Client  
 RFU  
 Project  
**TWICKENHAM STADIUM EAST STAND EXTENSION**

**PROPOSED LANDSCAPING SECTIONS**

Doc ref	Project number	Drawing number	Revision
100-KSS-DR	15735	007	P02

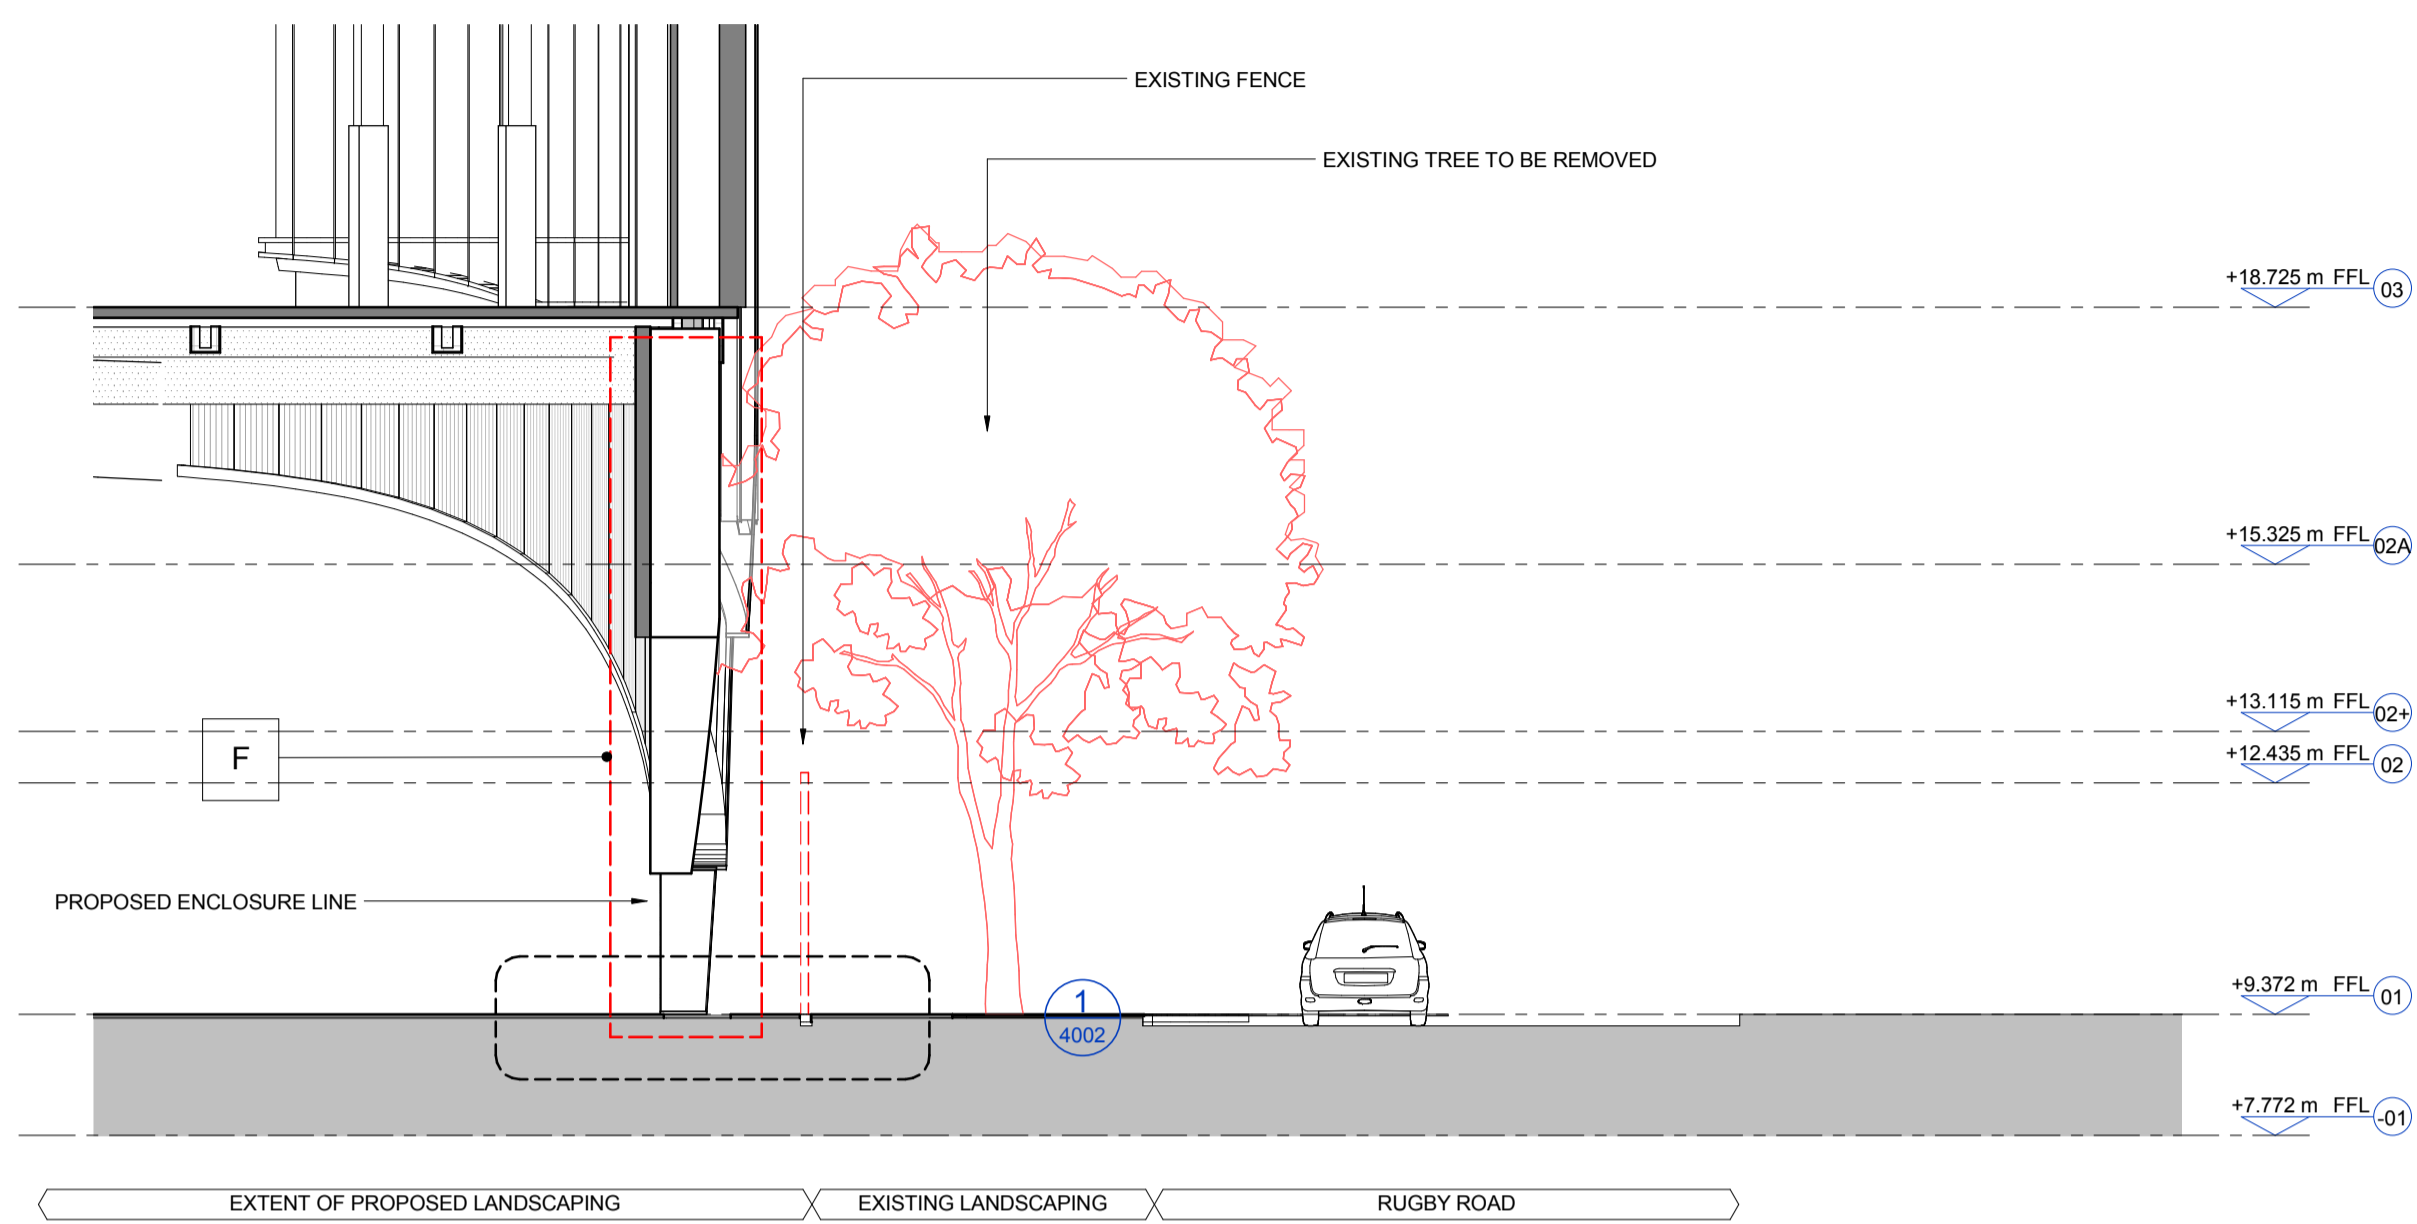
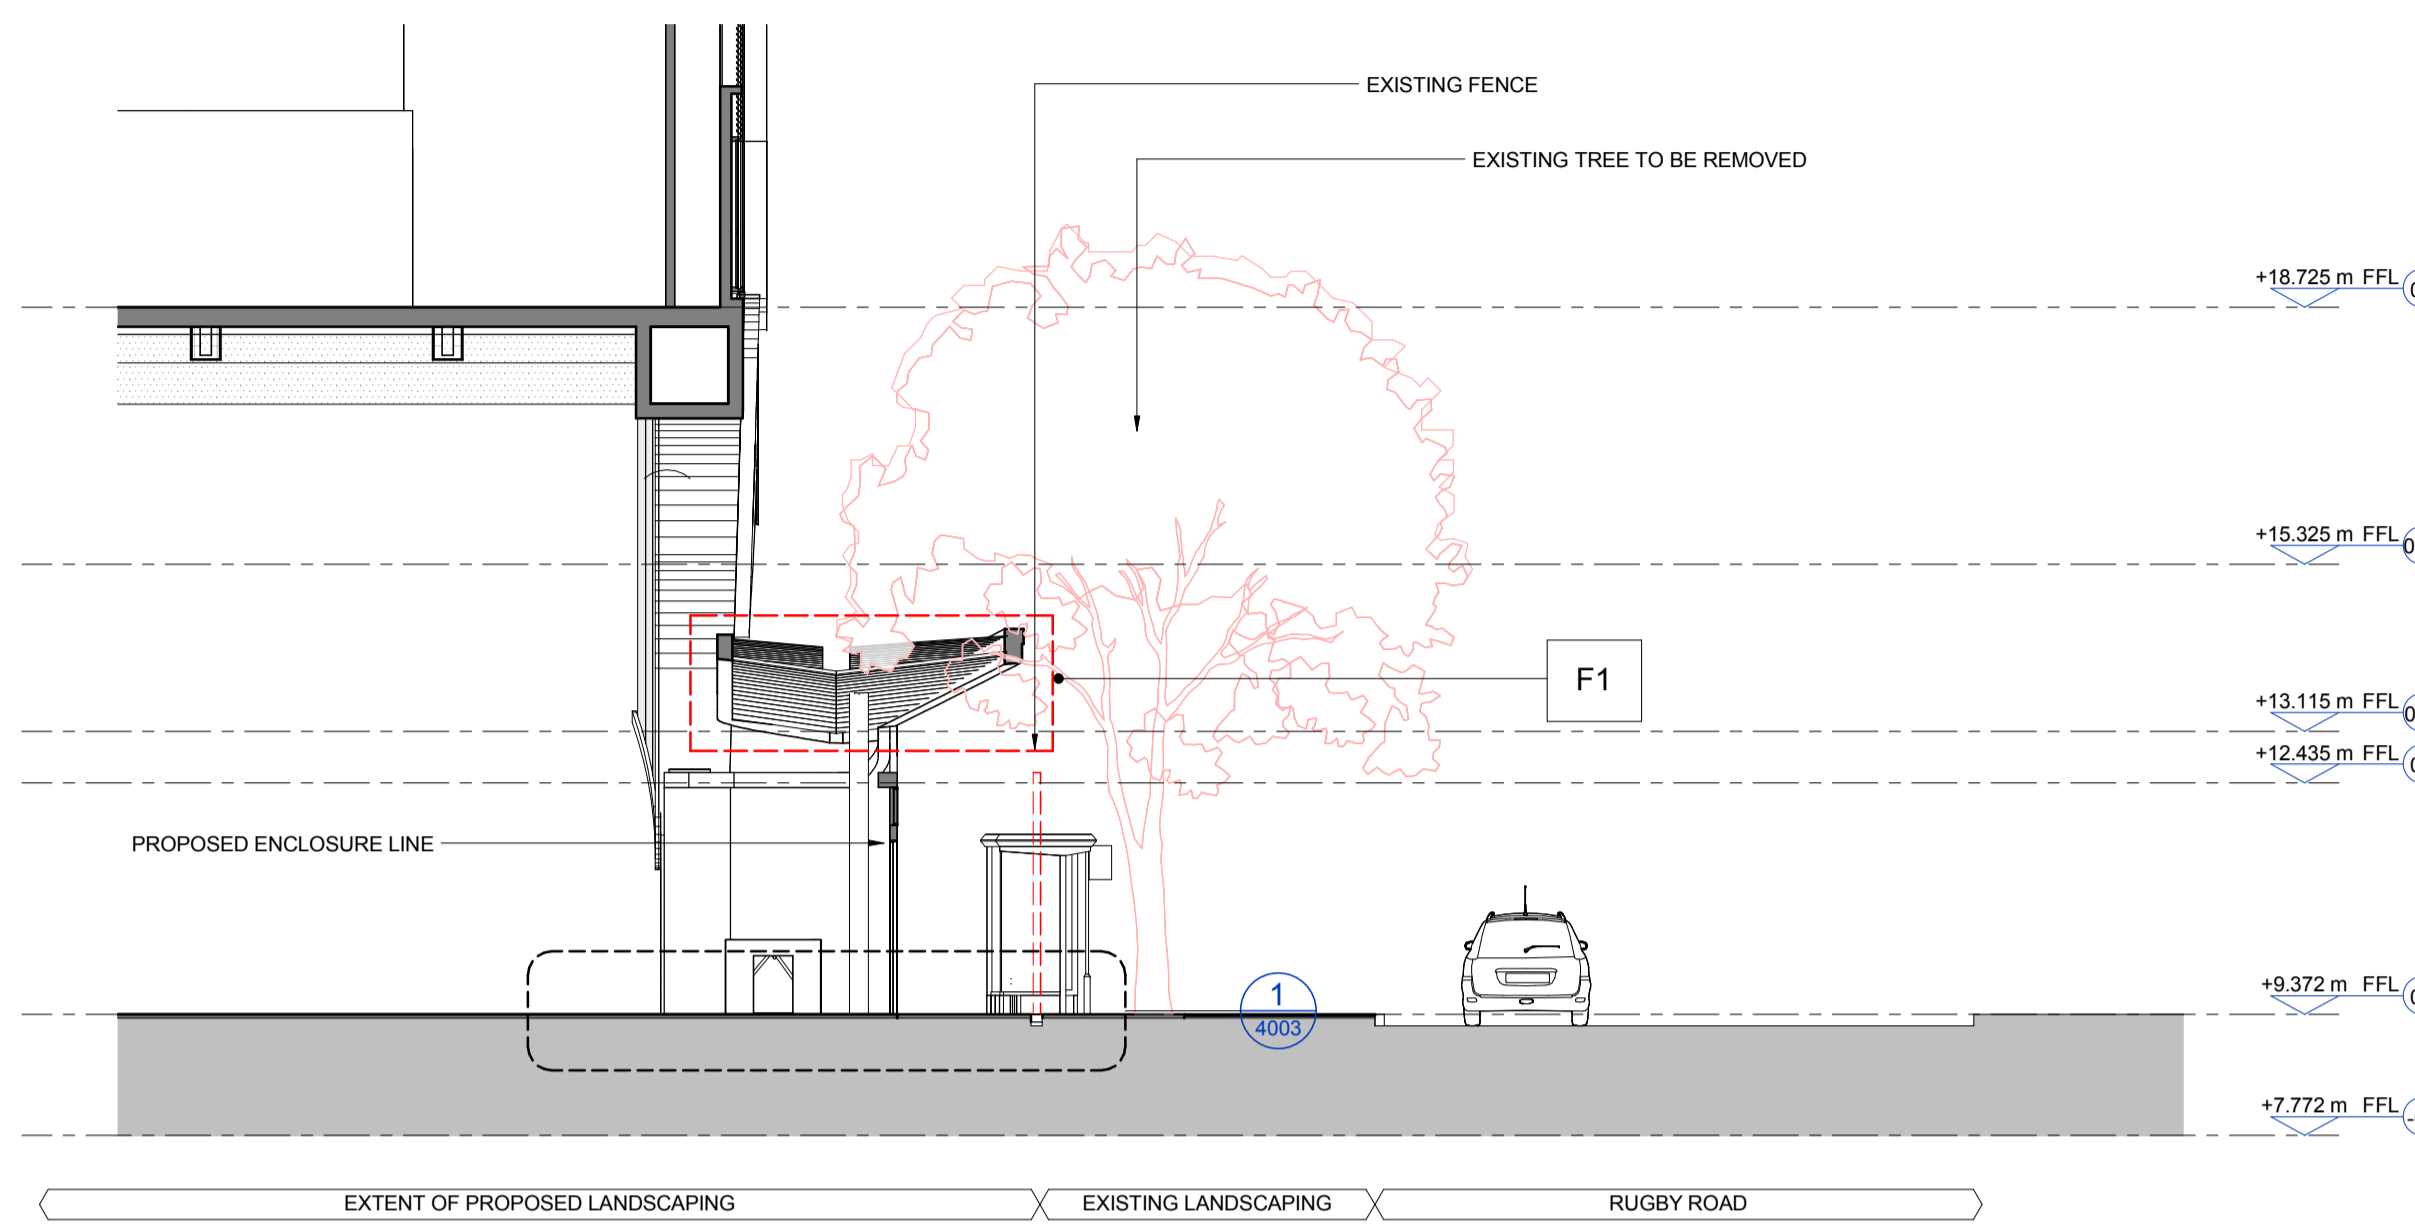
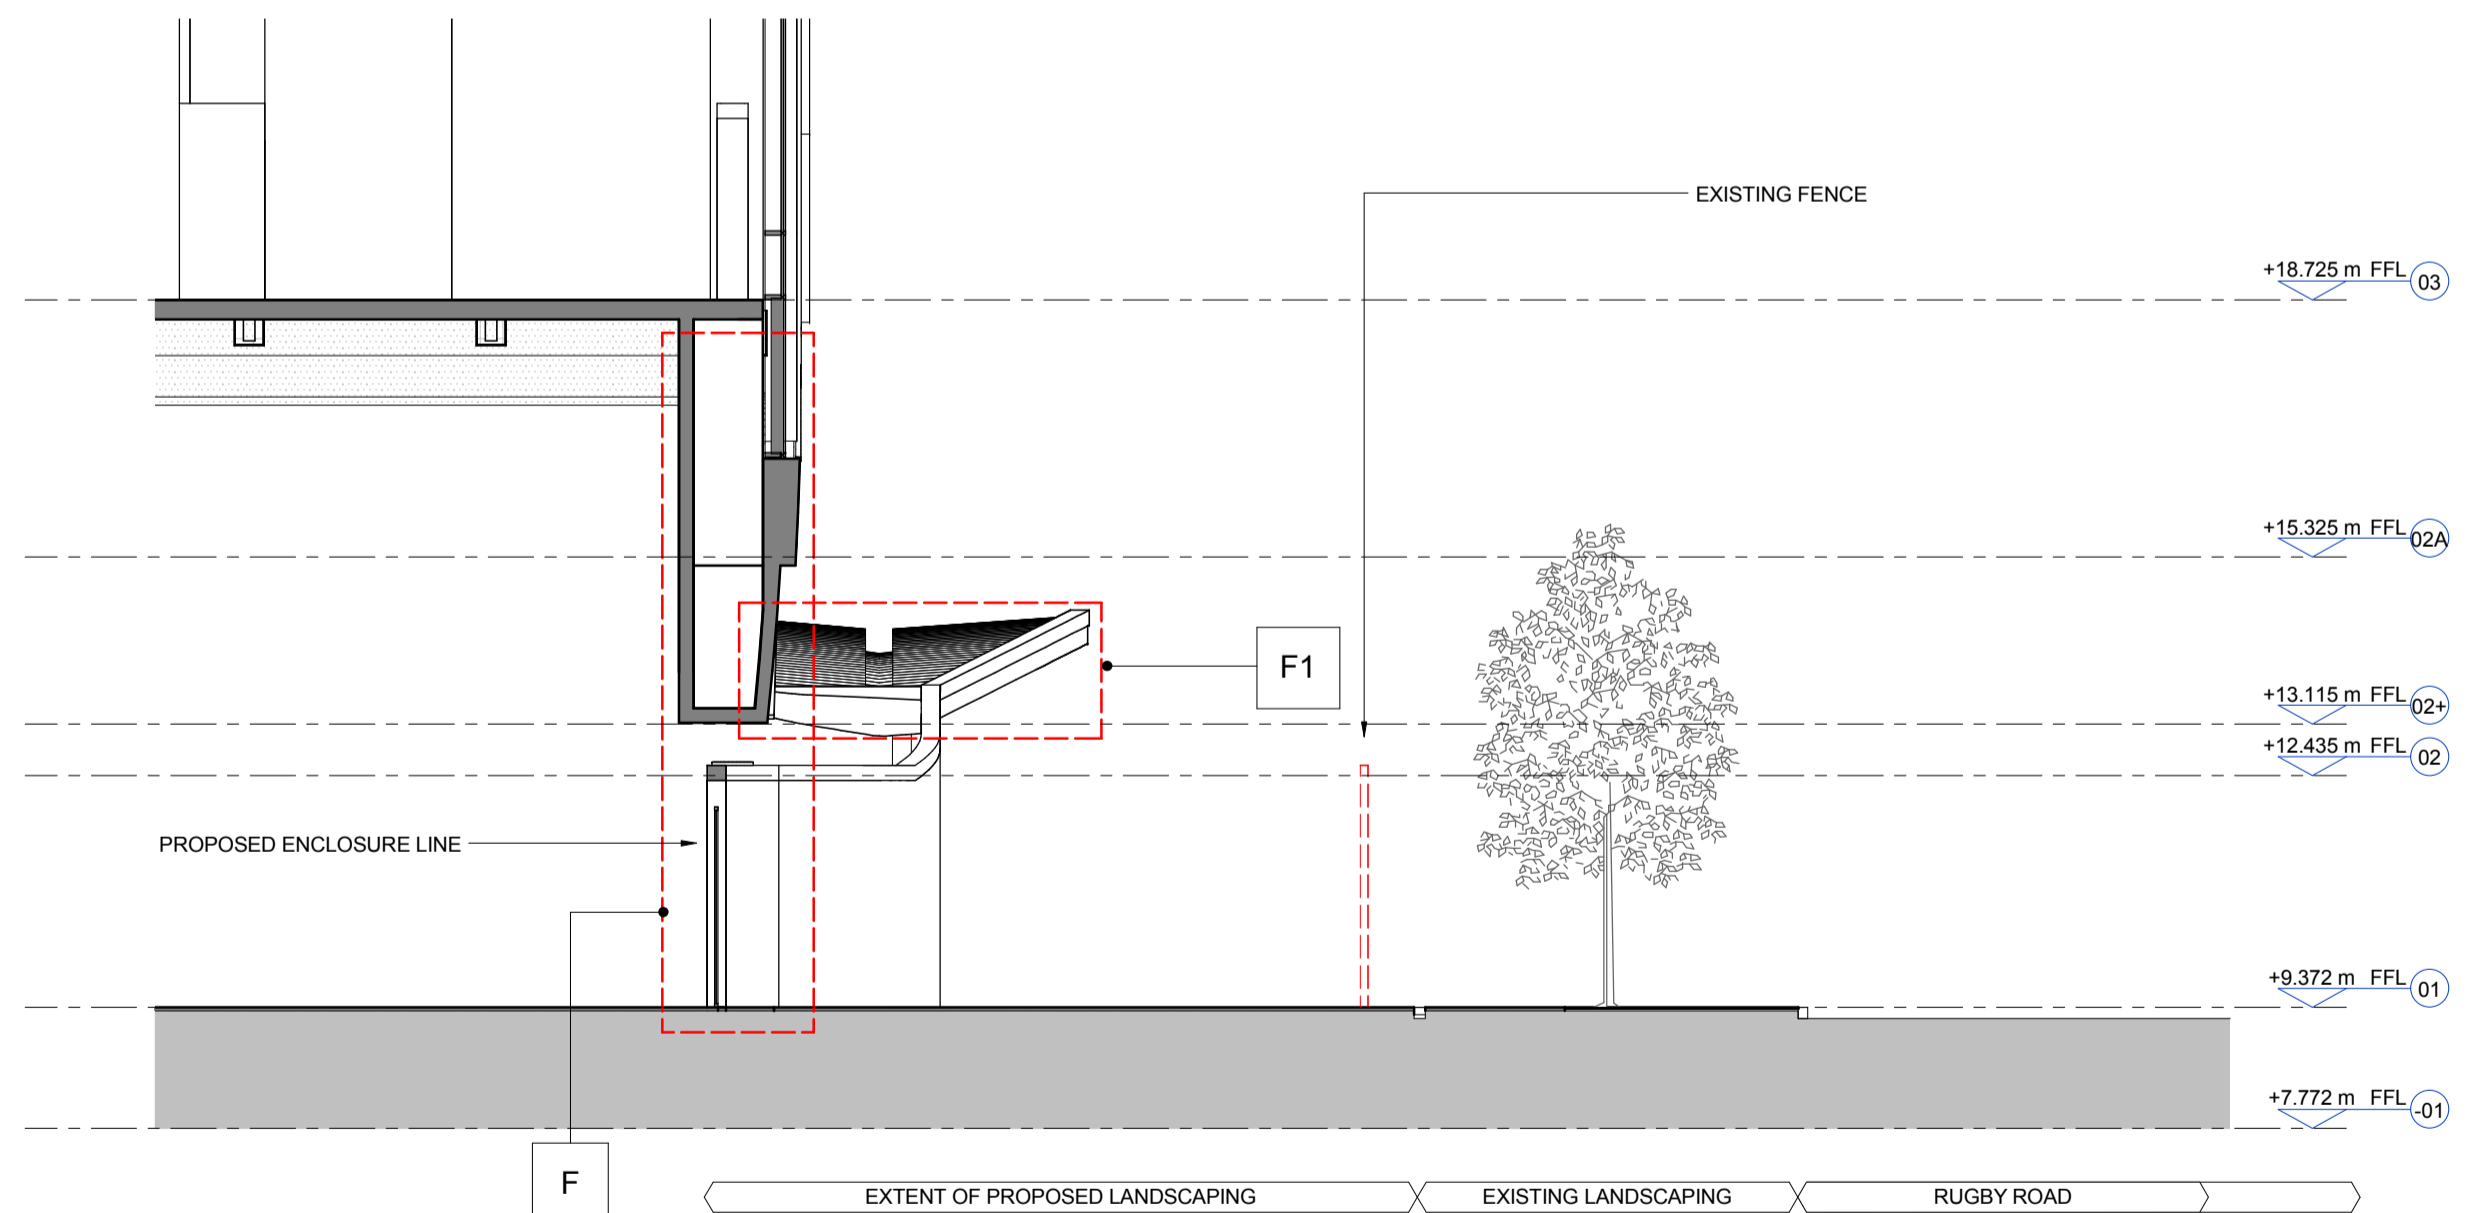
- A GENERAL AMENDMENTS TO THE SOUTH END.
- A1 INCREASED SHINGLES CLADDING AREA AND CURTAIN WALL REDUCED ACCORDINGLY.
- A2 REDUCED MASSING AND REVISED INTERFACE WITH THE SOUTH STAND.

- B PPC LOUVRES LOCATED TO THE BOWL SIDE HAVE BEEN OMITTED.
- C CURTAIN WALL SETTING OUT REVISED GENERALLY. SILICONE JOINTS TO TRANSOMS AND MULLION REPLACED WITH CAPPED SYSTEM. LEVEL 04 PPC LOUVRES SETTING OUT & HEIGHT REVISED. MONORAIL FOR ABSEILING REMOVED.

- D GENERAL AMENDMENTS TO THE CENTRAL ELEVATION CANOPY AT LEVEL 5A REVISED GENERALLY AND STANDING SEAM REPLACED WITH SINGLE PLY MEMBRANE. SUPPORT COLUMNS TO ROOF CANOPY REVISED. SQUARE FASCIA TO ROOF EDGE.

- D1 LEVEL 5A GLAZED SCREEN EXTENDED IN HEIGHT AND PPC LOUVRES INCLUDED AT LOW LEVEL.
- D2 INCREASED SHINGLES CLADDING AREA AND CURTAIN WALL AREA REDUCED ACCORDINGLY. FOUR VERTICAL FINES REMOVED.

- D3 PORCELAIN PANELS WITH SLOTTED HOLES FOR VENTILATION REPLACED WITH PPC LOUVRES. EXPRESSED HORIZONTAL PATTERN TO PORCELAIN PANELS OMITTED.
- E GENERAL AMENDMENTS TO THE NORTH END

- E1 PORCELAIN CLADDING REPLACED WITH PPC ALUMINIUM CLADDING.
- E2 GREEN WALL TO THE NORTH END EXTENDED AND PPC LOUVRES REMOVED.
- E3 INCREASED SHINGLES CLADDING AREA AND CURTAIN WALL REDUCED ACCORDINGLY.

- F FENCELINE, GATE AND PERIMETER COLUMNS SETTING OUT REVISED.
- F1 CANOPY TO TURNSTILES REVISED.
- G PORCELAIN PATTERN CHANGED FROM HORIZONTAL TO VERTICAL.

- H PORCELAIN PANELS TO THE SOFFIT OF THE ARCH REPLACED WITH PPC ALUMINIUM PANELS. PORCELAIN PANELS SETTING OUT REVISED.
- K ROOF TO LEVEL 5A (NORTH END) EXTENDED.

- L GLAZED SPANDREL PANELS REPLACED WITH METAL SPANDREL PANEL. PORCELAIN PANELS REPLACED WITH PPC ALUMINIUM CLADDING.
- L1 PPC LOUVRES INCLUDED FOR MECHANICAL VENTILATION.
